**LOCAL REVIEW BODY**

EAST RENFREWSHIRE COUNCILLOCAL REVIEW BODY14 September 2022Report by Director of Business Operations and PartnershipsREVIEW OF CASE - REVIEW/2022/06

ERECTION OF TWO STOREY REAR EXTENSION, INSTALLATION OF REAR DORMER  
AND ASSOCIATED ALTERATIONS

2. Application type: Full Planning Permission (Ref No:- 2021/0457/TP).
- Applicant: Mr James Macklin
- Proposal: Erection of two storey rear extension, installation of rear dormer and associated alterations.
- Location: 51 Mansefield Crescent, Clarkston, East Renfrewshire, G76 7EA.
- Council Area/Ward: Clarkston, Netherlee and Williamwood (Ward 4).

Drawing title:  
Existing Floor Plans

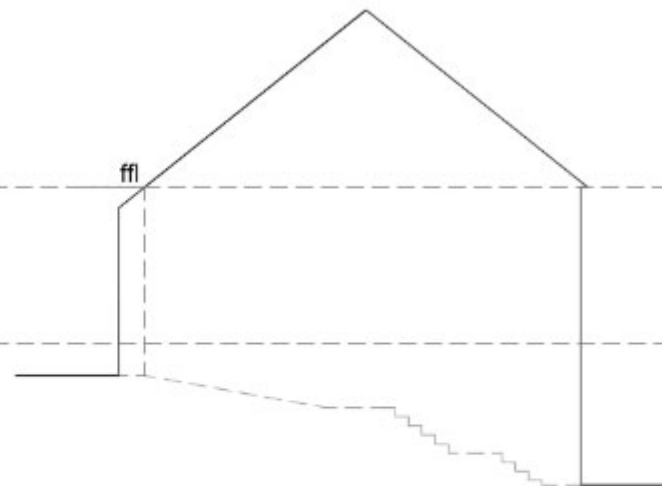
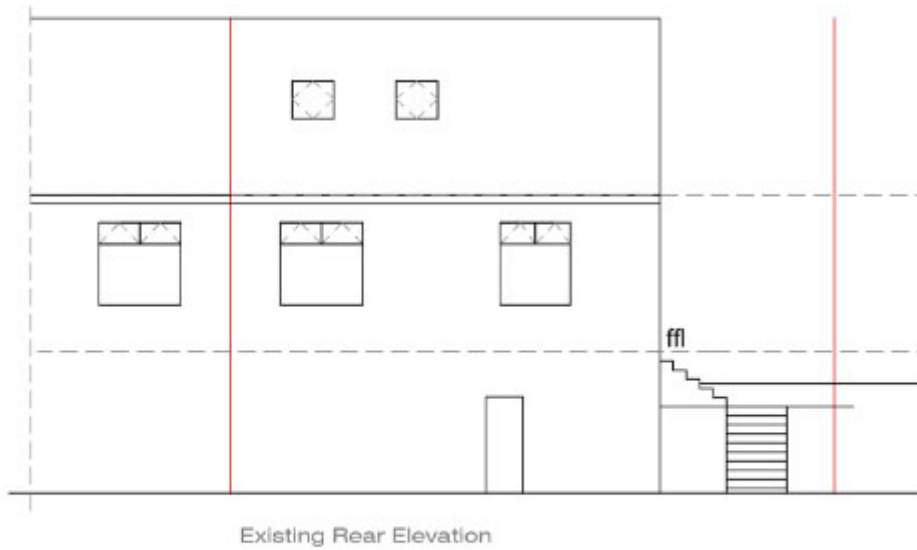
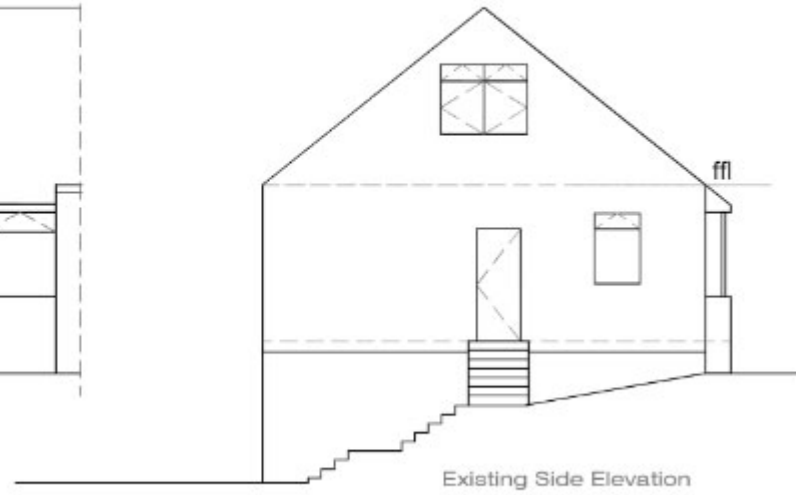
- The height of extending the existing ground floor (Plan Ref 002b) to create a new two tier building at the rear of 51 Mansefield Crescent (Proposed Plan Ref 004b), would tower over our back garden and the rear of our house resulting in immediate, and irreversible, loss of privacy at 34 Sunnybank Drive

- The height of extending the existing ground floor (Plan Ref 002b) to create a new two tier building at the rear of 51 Mansfield Crescent (Proposed Plan Ref 004b), would tower over my back garden and the rear of my house resulting in immediate, and irreversible, loss of privacy at 34 Sunnybank Drive

Drawing title:  
Proposed Plans

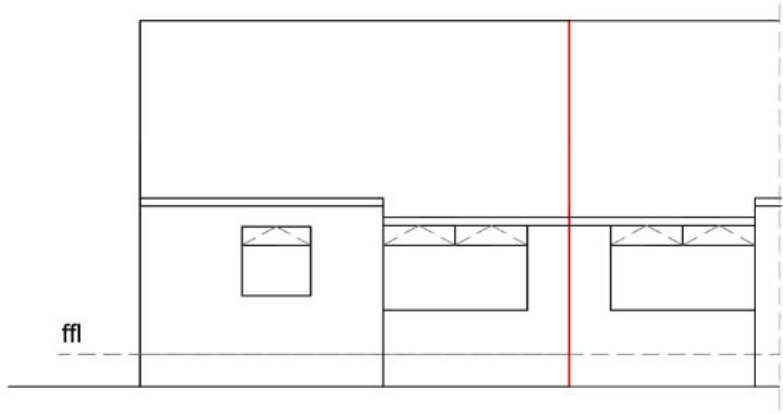
- The height of extending the existing ground floor (Plan Ref 002b) to create a new two tier building at the rear of 51 Mansefield Crescent (Proposed Plan Ref 004b), would create shading and reduce sunlight to our garden, adversely affecting both our enjoyment of the garden and surrounding vegetation

- The height of extending the existing ground floor (Plan Ref 002b) to create a new two tier building at the rear of 51 Mansfield Crescent (Proposed Plan Ref 004b), would create shading and reduce sunlight to my garden, adversely affecting both my enjoyment of the garden and surrounding vegetation

Proposed Front Elevation

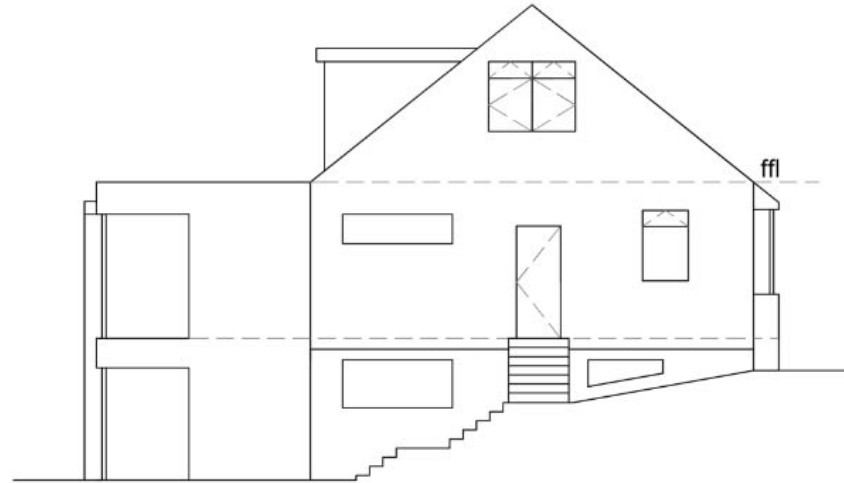
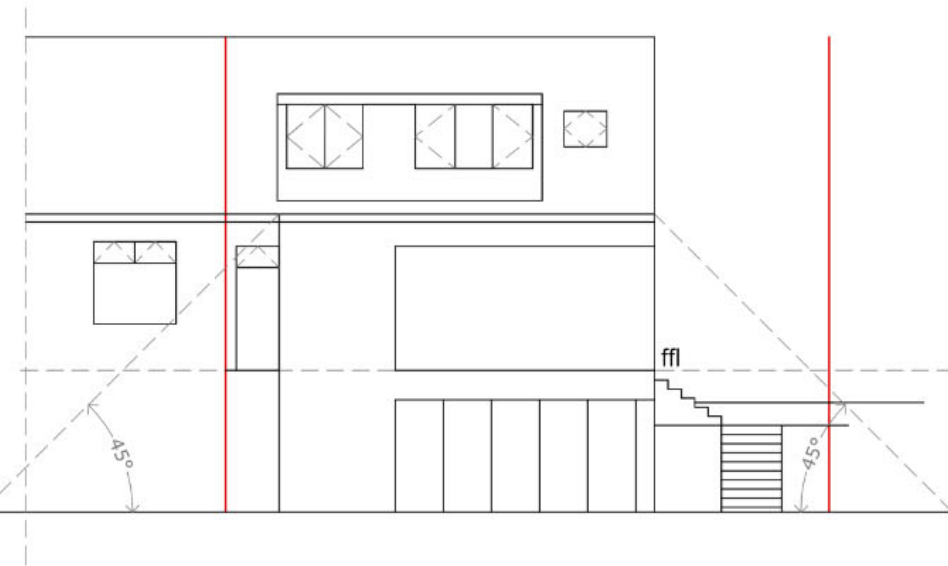
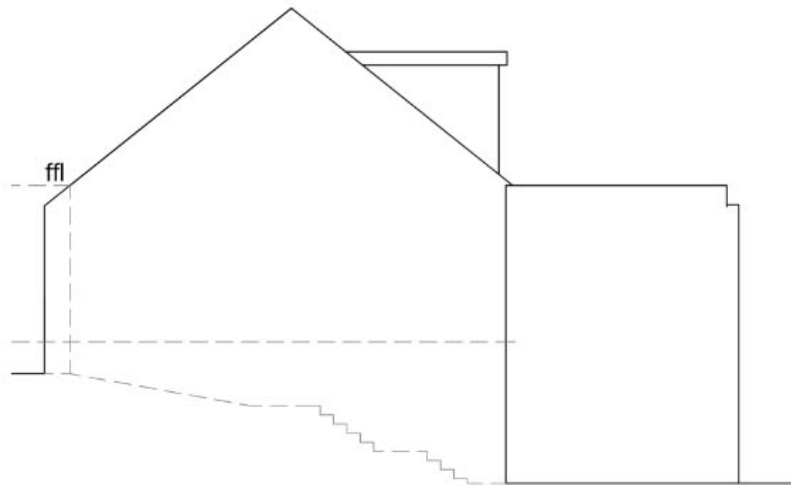
- Calculated from the proposed side elevation on Plan Ref 005b, the proposed extension to the rear of 51 Mansfield Crescent would be a permanent structure built 4.3m closer to our back garden (+50% of the current width of 51 Mansefield Crescent according to the Plan)

- Calculated from the proposed side elevation on Plan Ref 005b, the proposed extension to the rear of 51 Mansfield Crescent would be a permanent structure built 4.3m closer to our back garden (+50% of the current width of 51 Mansfield Crescent according to the Plan)
